RE: 657-703 Mamre Road, Kemps Creek – Amendments of the Exhibited Proposal (SSD 9522)

1 Introduction

Traffic Impact Assessment

Proposed Warehouse, Logistics and Industrial Facilities Hub
657-769 Mamre Road, Kemps Creek

Figure 1: Intersection Configurations – Mamre Rd / Bakers Ln (SLR) – Previous Proposal

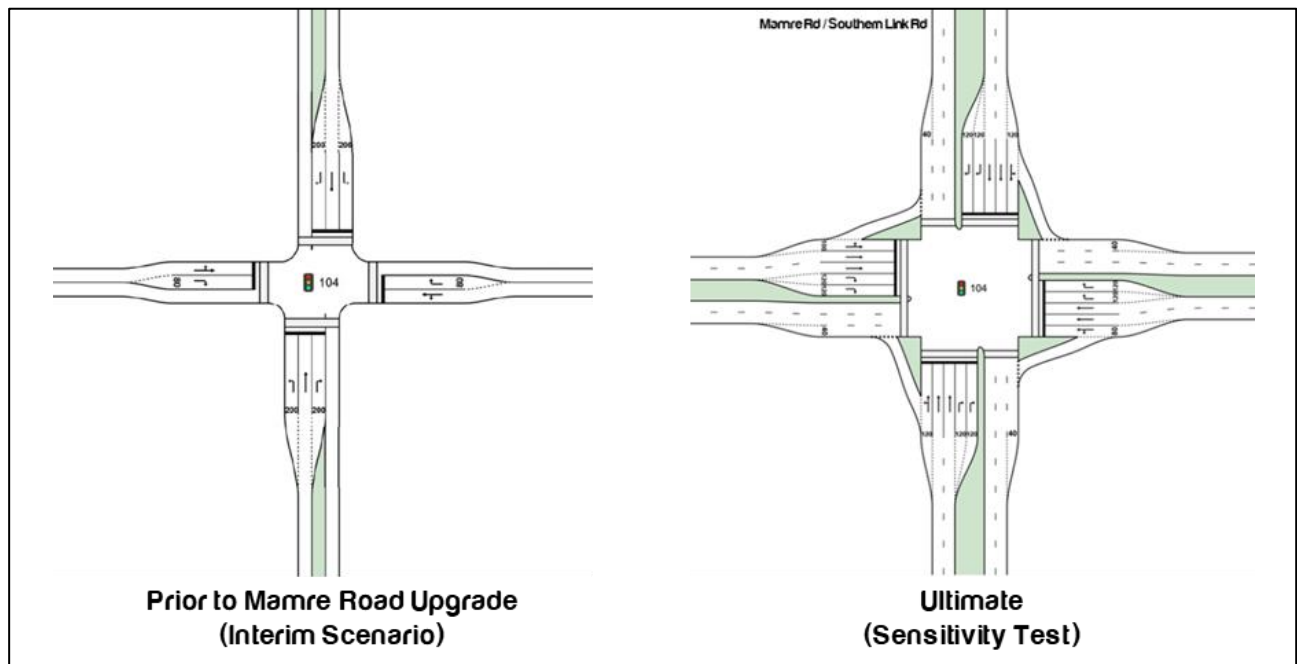
Additionally, the Proposal now includes a new connection to the land to the south to provide access to the potential Southern Lots. In the previous TIA, future baseline SIDRA model has been developed for intersections along Mamre Road in the vicinity of the MSP in accordance with Mamre Road Upgrade strategy, and some additional improvements are suggested for the Mamre Road x Balers Lane (Southern Link Road) intersection, as shown below.

Figure 2: Sequence (1A) Mamre Road / Bakers Lane Signal layout

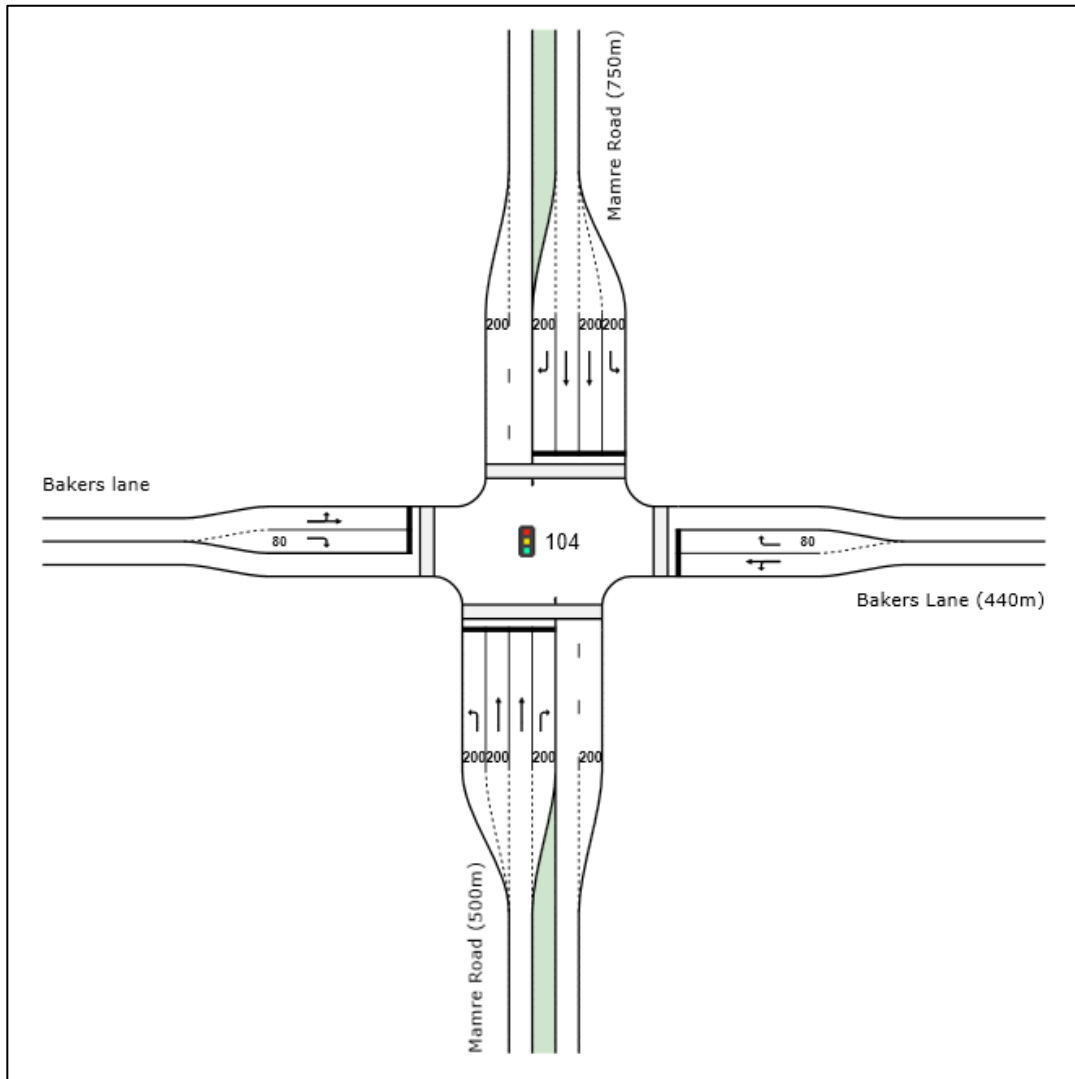
An interim access connection which will be provided to/from the upgraded Mamre Road / Bakers Lane signalised intersection as presented in **Figure 1**. This sequence plan has been proposed to accommodate the SSD with 166,225 m² GFA and up to 2025 design year.

Figure 3: Sequence (1B) Mamre Road / Bakers Lane Signal layout

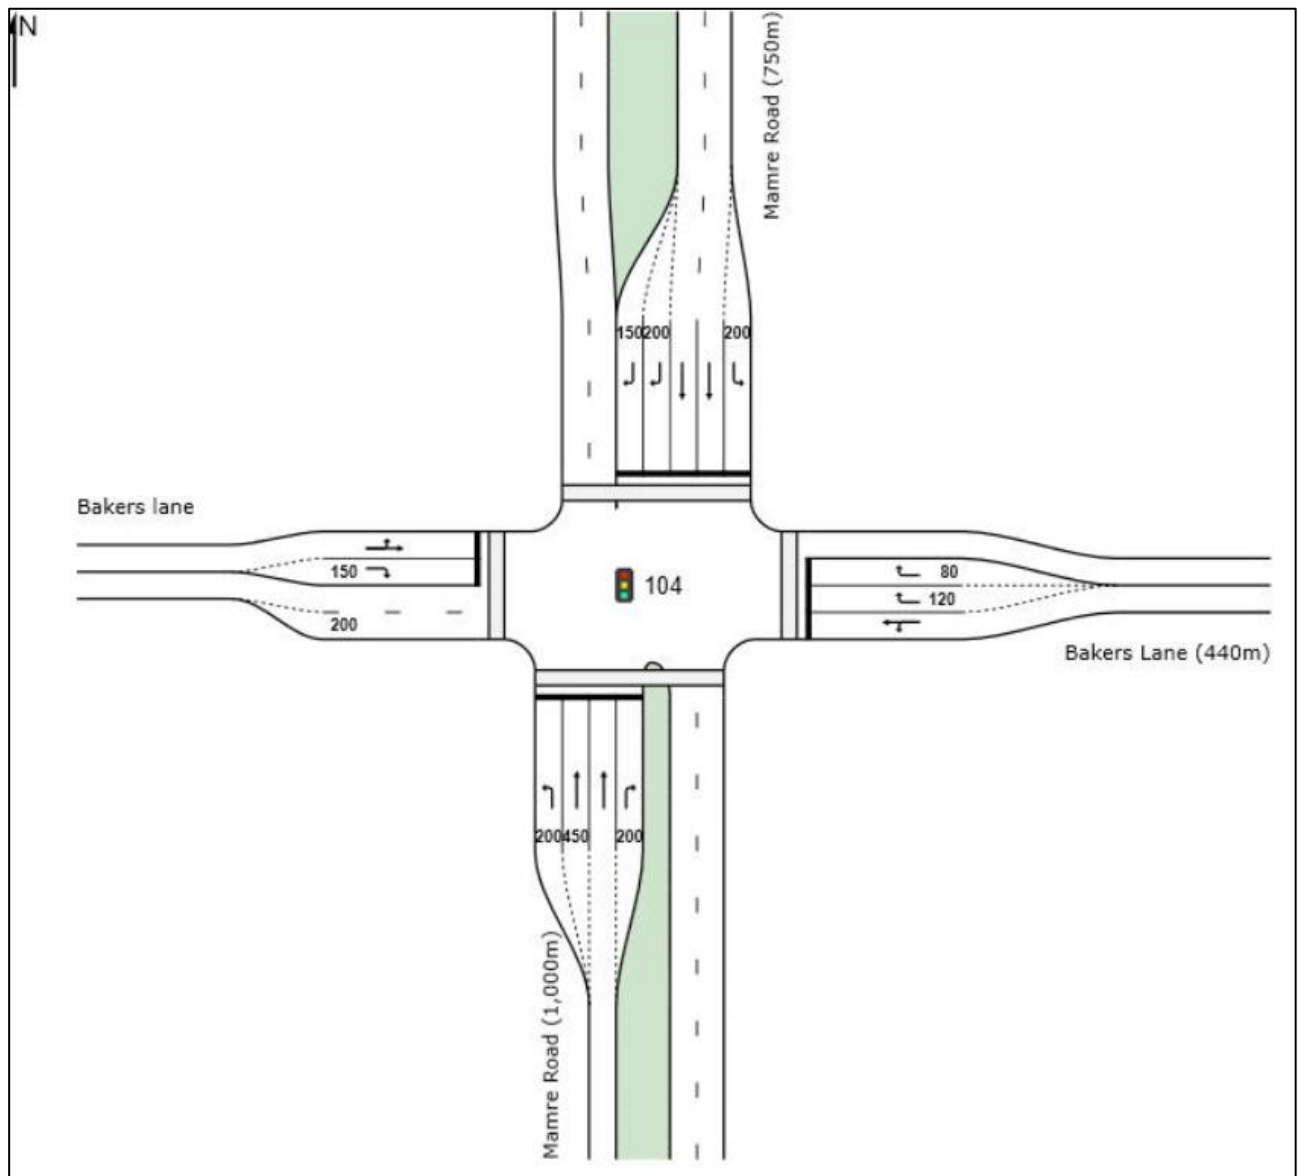
It is noteworthy that Frasers and Altis intend to upgrade Mamre Road in this vicinity to 2 lanes in each direction (4 lanes in total) from the southern boundary of the Site to the signalised intersection of Mamre Road/Distribution Drive.

Sequence 1B will therefore, follow Sequence 1A and is proposed to be delivered following completion of 4-lanes on Mamre Road from the southern boundary of the Site to the existing signalised intersection of Distribution Drive (offered by FPA and Altis). This Sequence is proposed to essentially accommodate the traffic from the ultimate masterplan (with 421,820 m²) and the Southern Lots as well as the background growth after 2025. This Sequence shall be implemented should Altis OR FPA (OR Southern Lots) wish to increase the GFA over 166,225m² or by end of 2025 (Sequence 1A design life).

Figure 4: Sequence (2) Mamre Road / Bakers Lane Signal layout

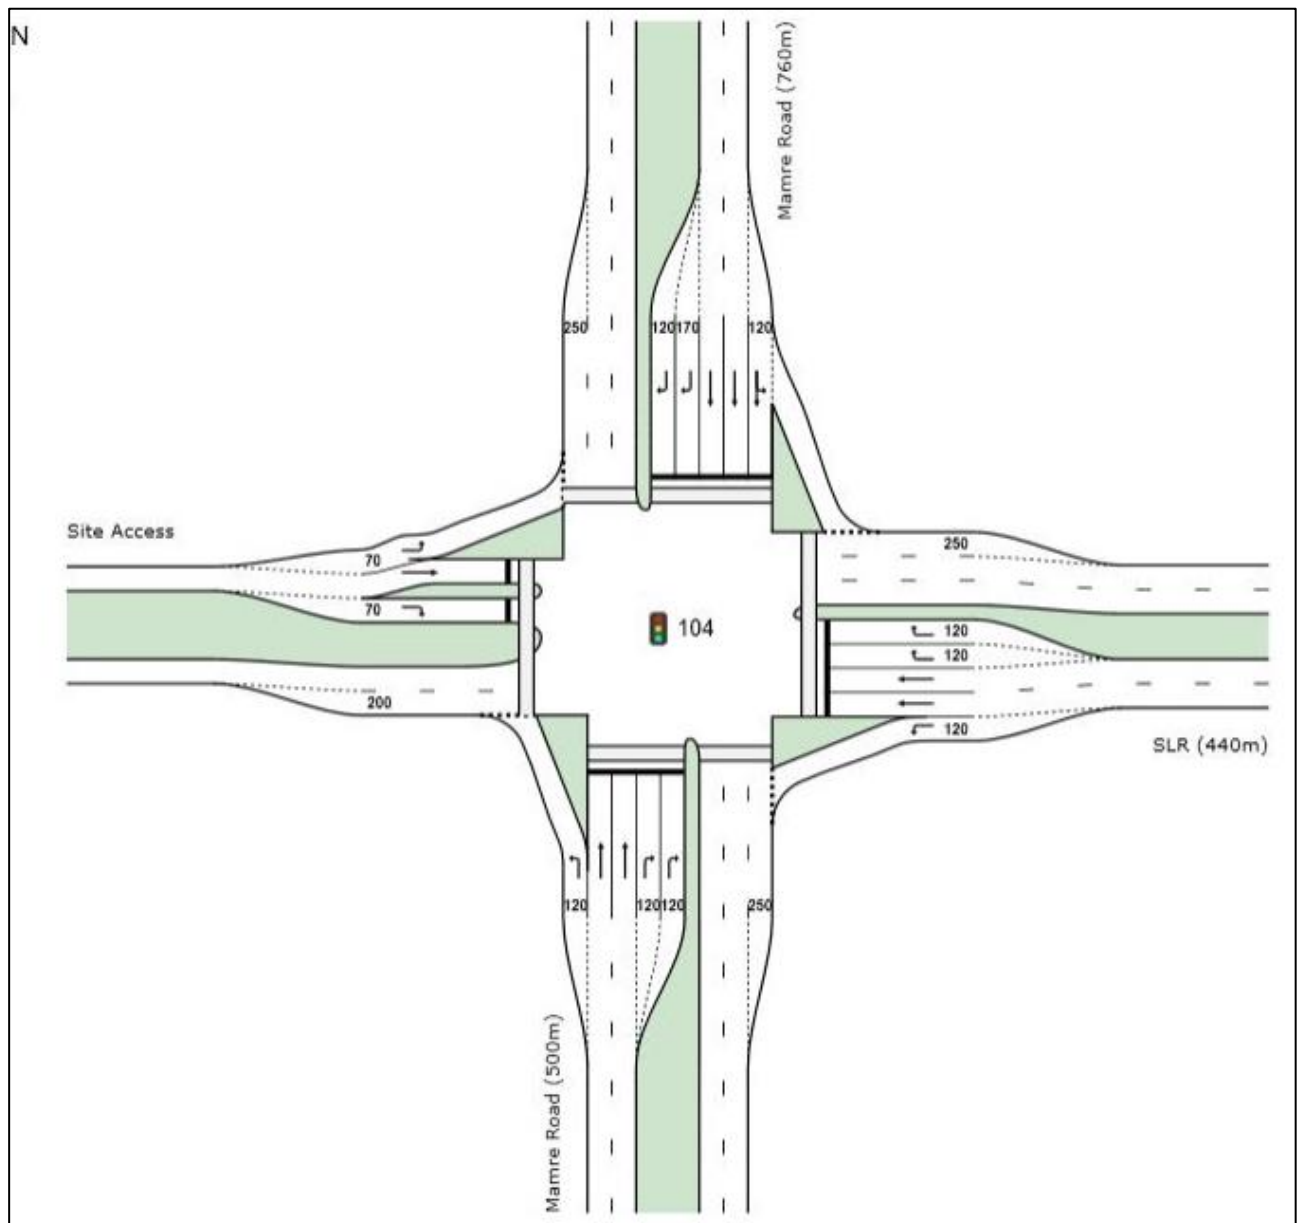
Sequence 2 will be delivered in the longer-term future and when Southern Link Road (SLR) will be delivered by TfNSW and terminated as a cul-de-sac at the access to the Site.

Figure 5: Sequence (3) Mamre Road / Bakers Lane Signal layout

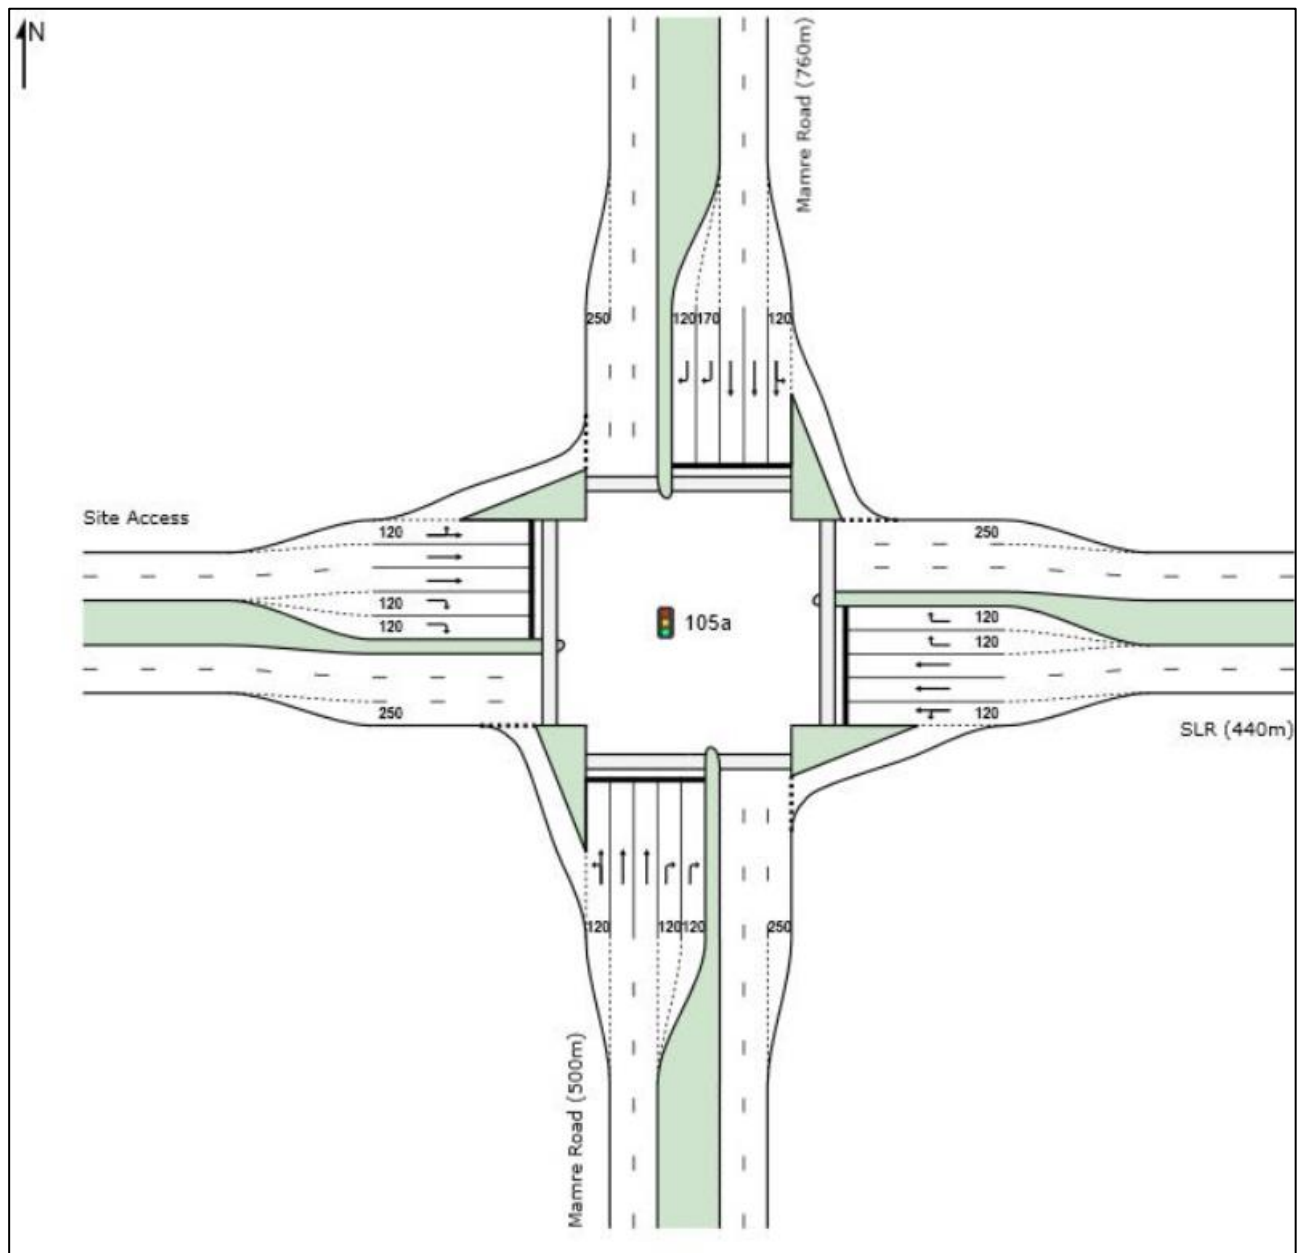
Sequence 3 shows the ultimate configuration of the SLR in future and when it is extended west through the Site.
